Architectural Review Board Staff Report

Project Type: 3rd Amended Site Development Plan

Meeting Date: June 8, 2017

Description: **Dierbergs the Market Place 3rd Amended Site Development Plan:** An Amended Site Development Plan, Partial Amended Landscape Plan, Amended Architectural Elevations and Architect's Statement of Design for an 11.35 acre tract of land zoned "C-8" Planned Commercial District located east of Clarkson Road and north of Baxter Road.

Figure 2: Existing parking lot island

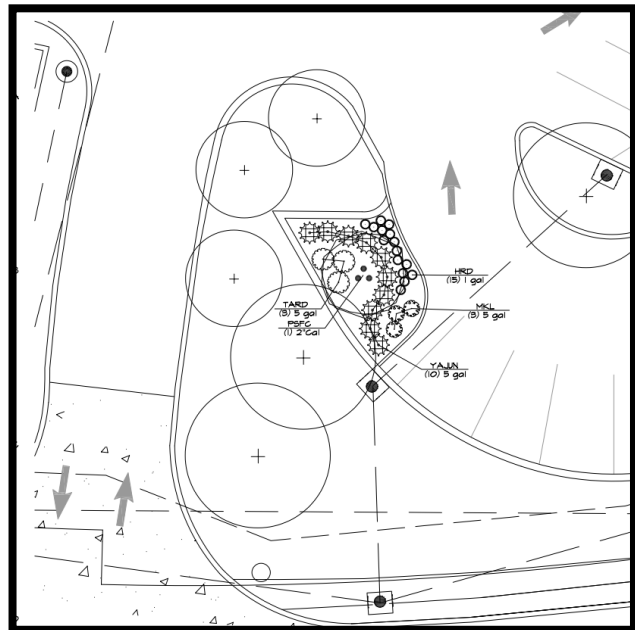
The proposal does include an expanded and heavily landscaped parking lot island near the southwestern entrance to the site. This would remove two awkward parking spaces as shown below, and increase the amount of vegetation on site.

Figure 4: Proposed front elevation

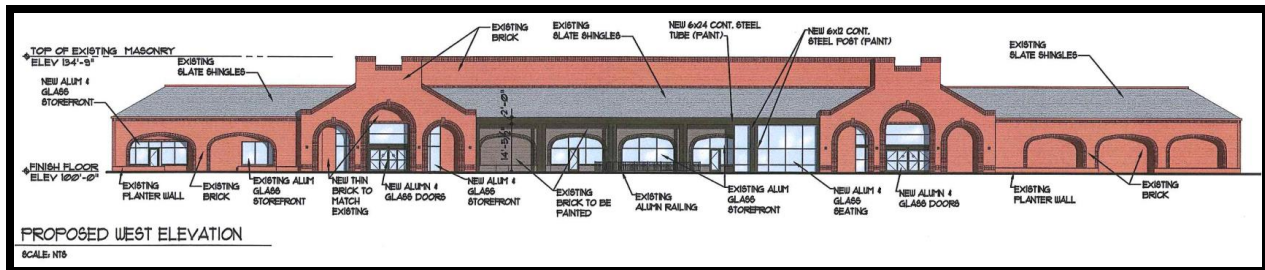
The proposed changes along the front façade will alter the appearance of the building and add elements of human scale, such as a colonnade and new windows. Additionally, the brown paint color at the rear of the colonnade is intended to add a multidimensionality. The overall building height and scale, however, is not changing.
